Comments were made with report submitted with Filing 1 (SF-22-004). Address those comments and resubmit updated copy of report.

FINAL DRAINAGE PLAN

THE RIDGE AT LORSON RANCH

FILING NO. 1: SF 22-004

SHEET NUMBER **C9.6**
TOTAL SHEETS: 23

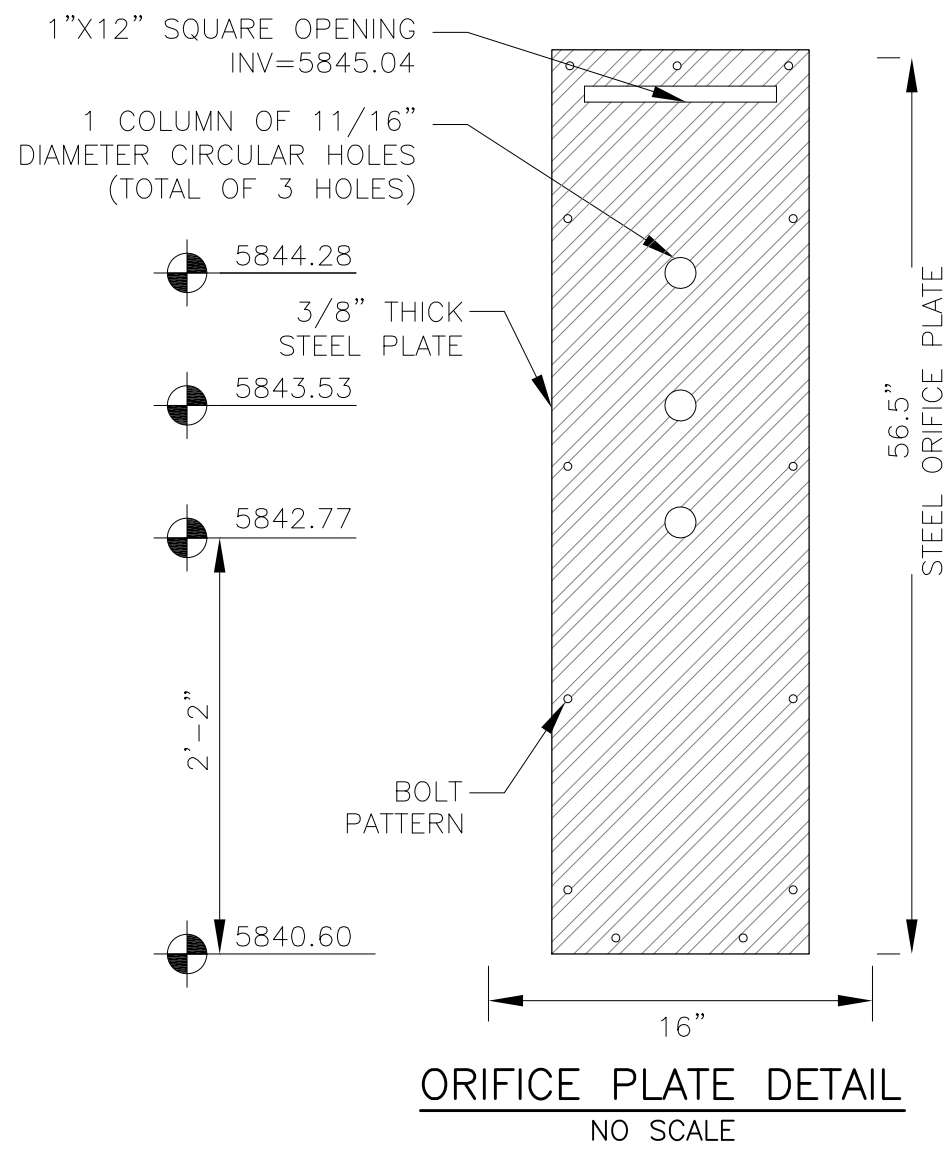
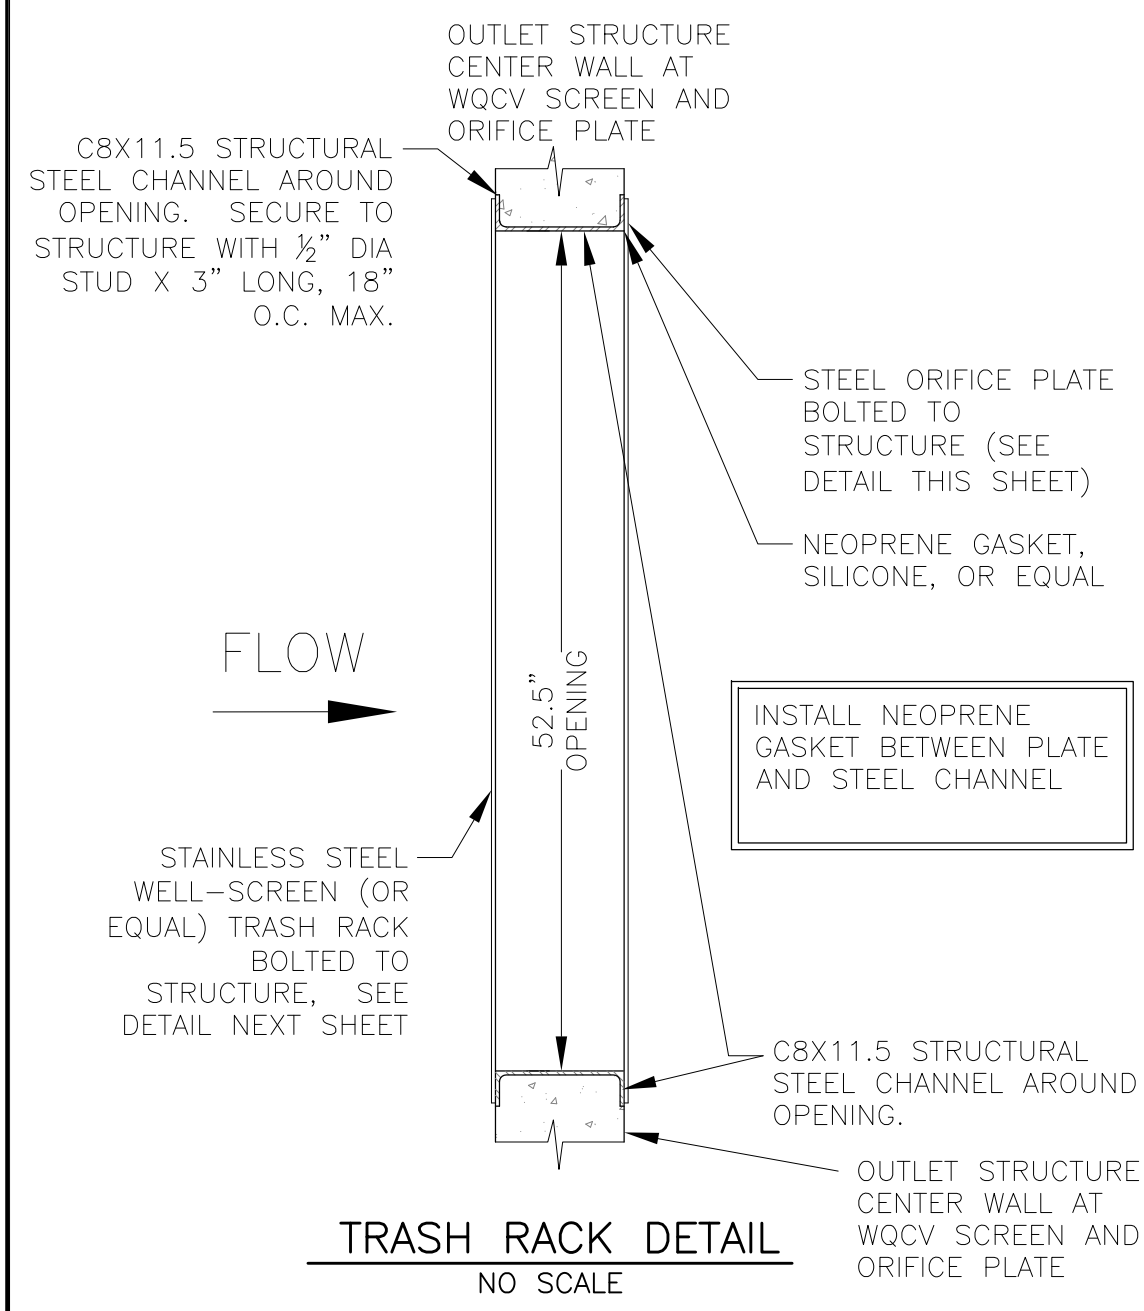
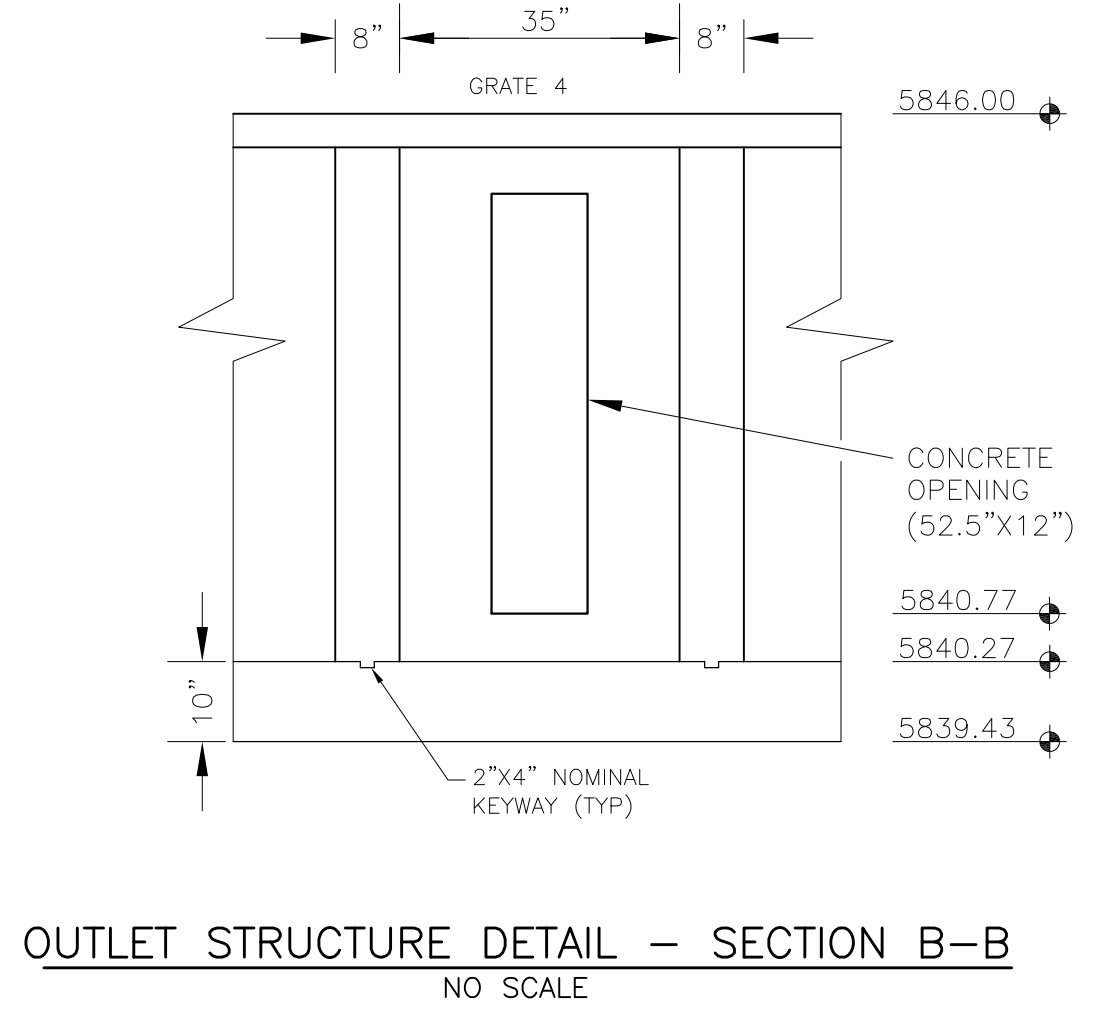
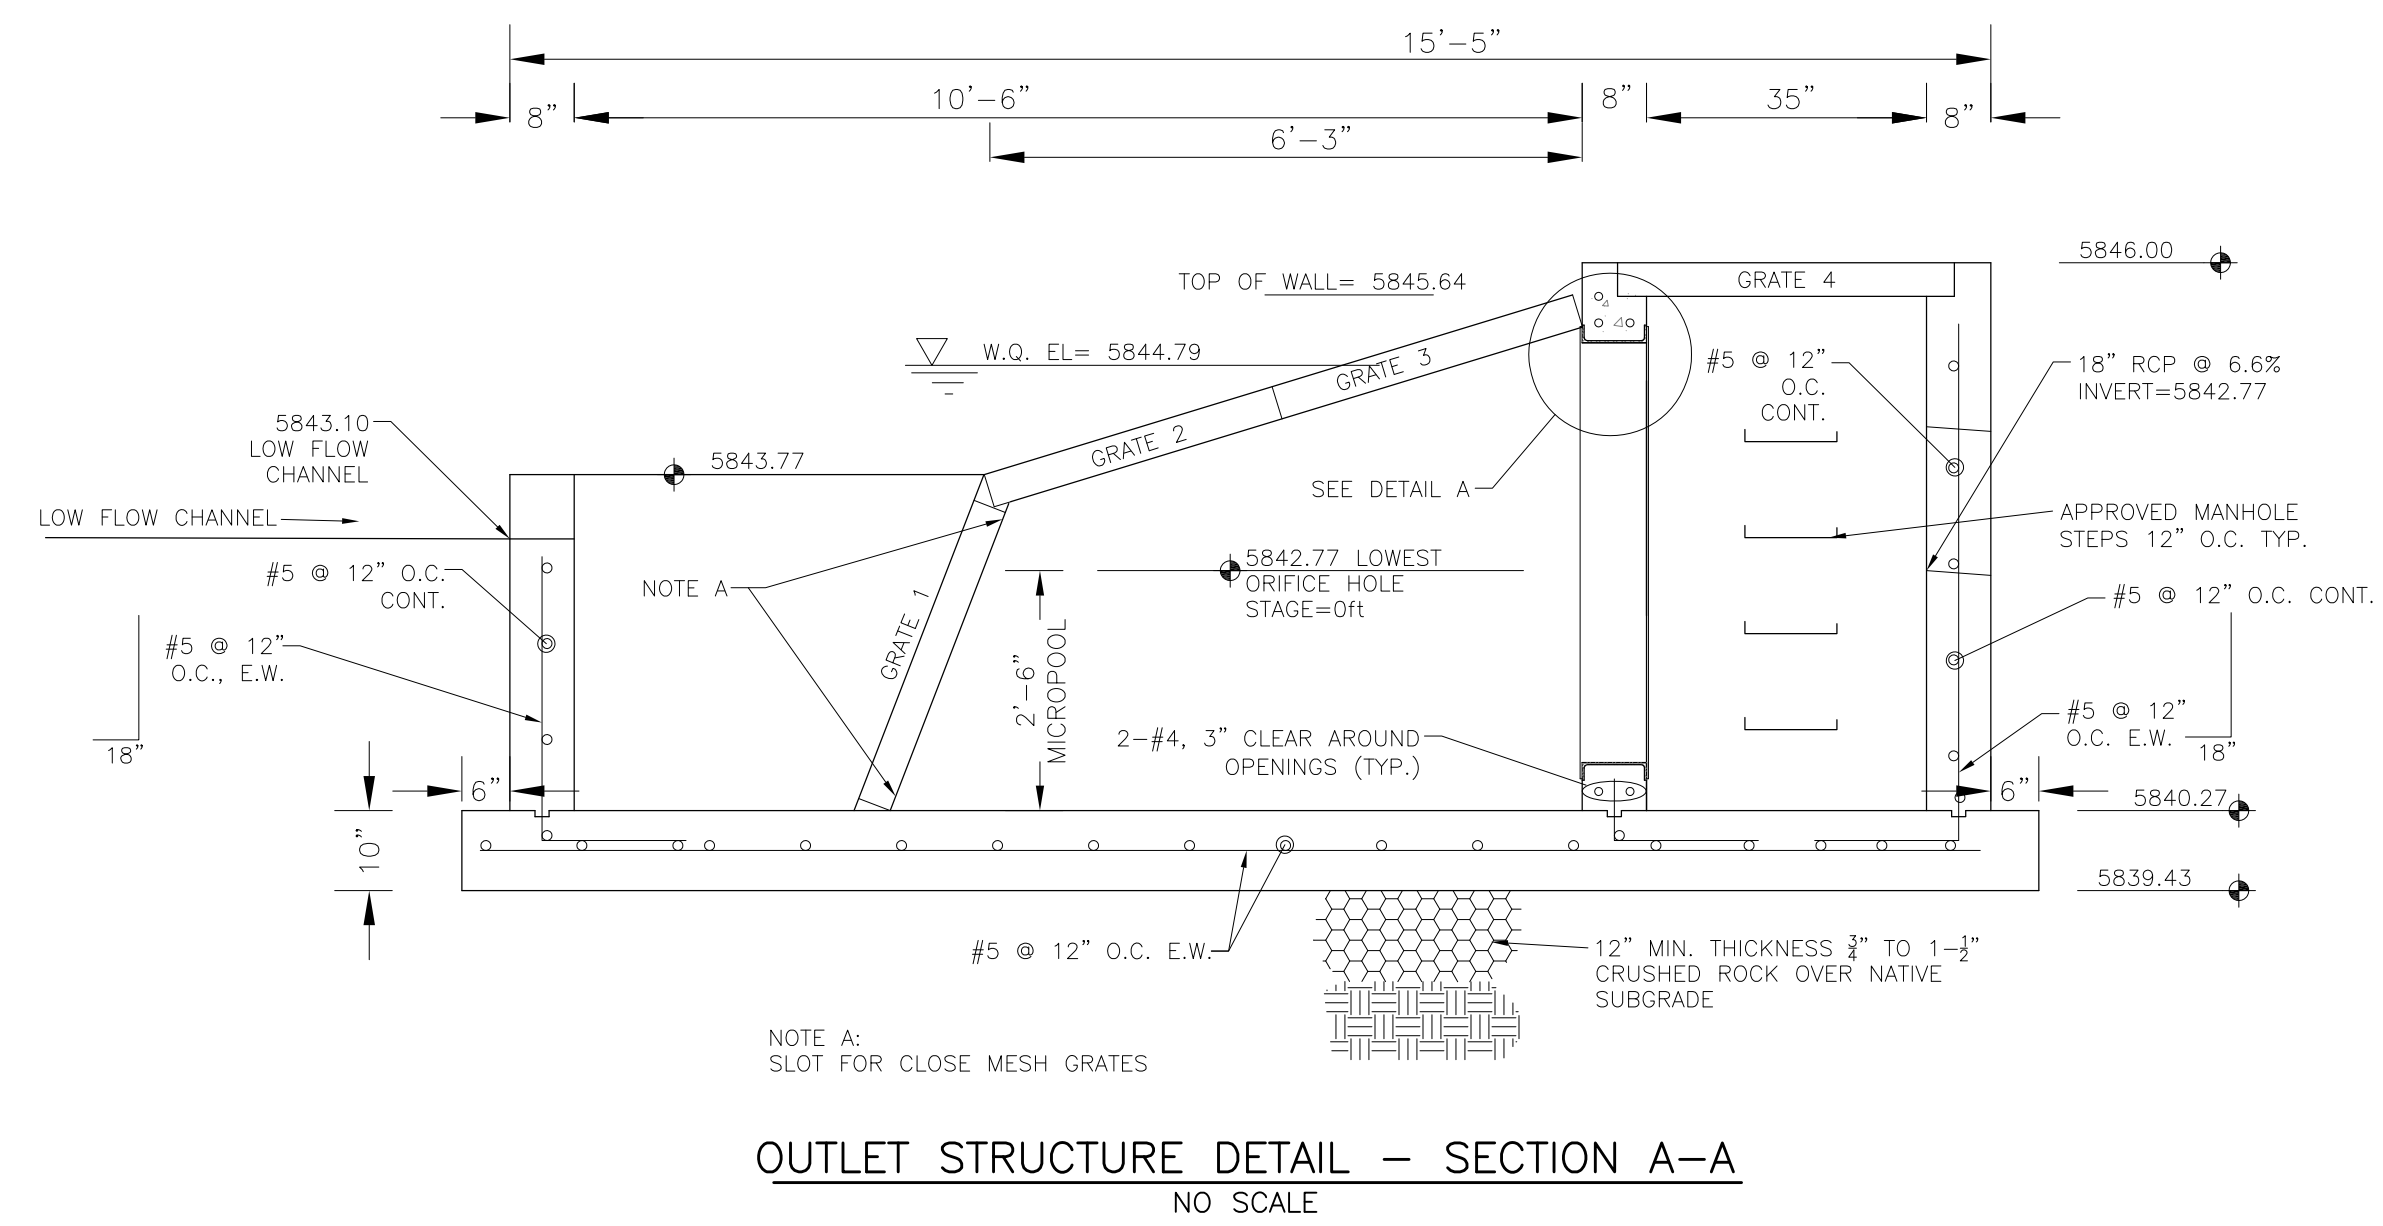
Unresolved: should be 36" per pg 199 above.

Unresolved: should be 72" per pg 199 above.

Review #2 update:
Revise outlet structure accordingly or revise MAFD calcs on pg 204 to reflect this outlet configuration so there is not a discrepancy.
